## Field Report #3

**Project:** Casco Bay PG – Stair/Elevator Tower Restoration  
**Project #:** WO 3604  
**Date/Time:** February 25, 2016, 10:45 a.m.  
**Observers** Adam Sampson (BSE), Joshua Martin-McNaughton, Author (BSE)

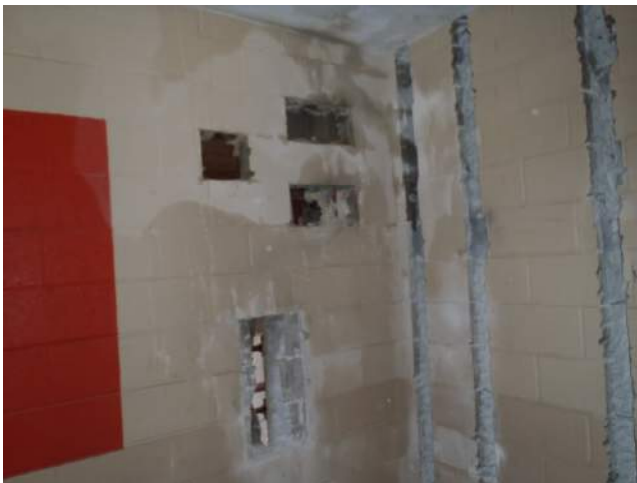
3. The two flat roof W-shape beams that are supposed to be supported by the CMU wall have minimal bearing (less than 2 inches). See adjacent photo. It appears that the demolished split face block provided the support for the beams. KISC has temporarily shored the beams. BSE is looking into options for supporting the beams and may include an HSS column extending down to the existing foundation. The alteration to support the beams will require a change order.
